Team Update 03

GENERAL

Figure 8-2 Examples of G24 compliance and non-compliance

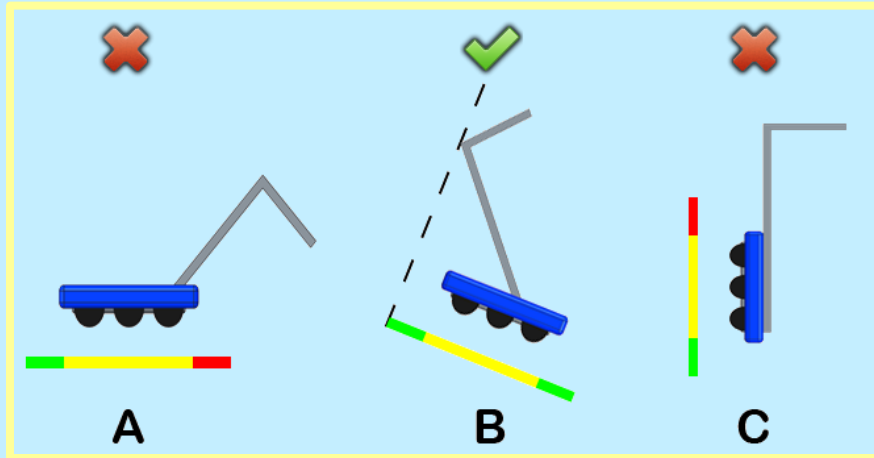
G24. Don't overextend yourself. ROBOTS may not extend more than 30 in (~76 cm). beyond their FRAME PERIMETER (see Figure 8-2).

Examples of compliance and non-compliance of G24 are shown in Figure 8-2.

Yellow bars represent the limits of the FRAME PERIMETER and are drawn in the same orientation of the ROBOT'S FRAME PERIMETER. Green bars represent a measured extension from the FRAME PERIMETER that has not been exceeded. Red bars represent a measured extension from the FRAME PERIMETER that has exceeded the limit in G24). ROBOTS A and C violate G24, whereas ROBOT B does not.

Figure 10-6 BUMPER Vertical Cross Section

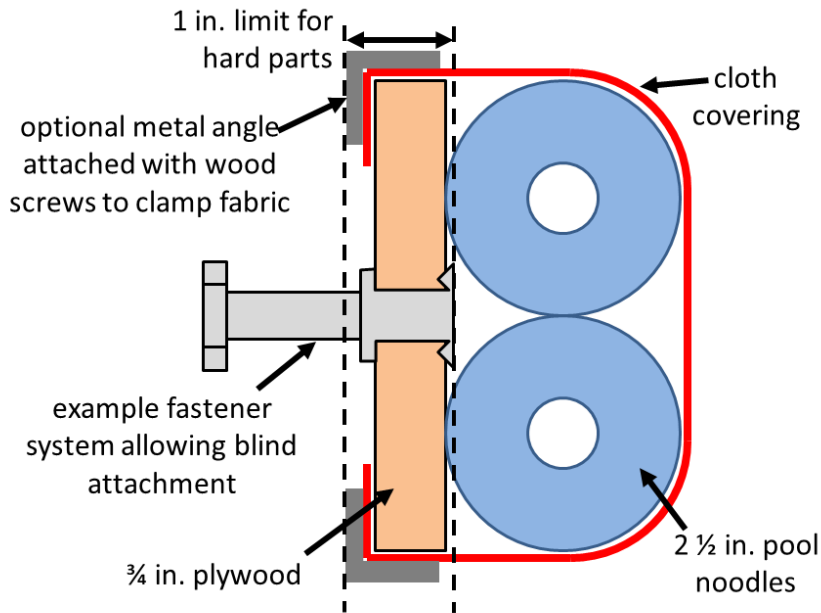
- R31. (Figure 10-6, change is “optional aluminum metal angle attached with wood screws to clamp fabric” in callout)

Figure 10-7 Soft Parts of BUMPER Corners

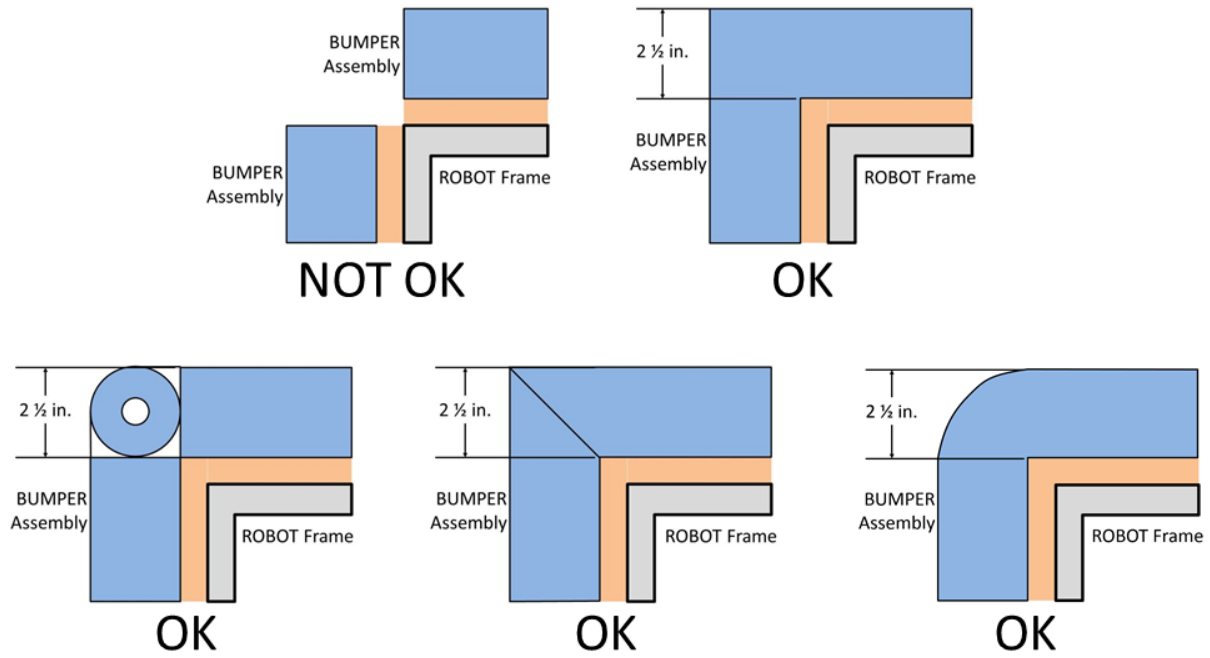
- R32. (Figure 10-7, modified to better represent that the bottom right example is a noodle wrapped around the corner.)
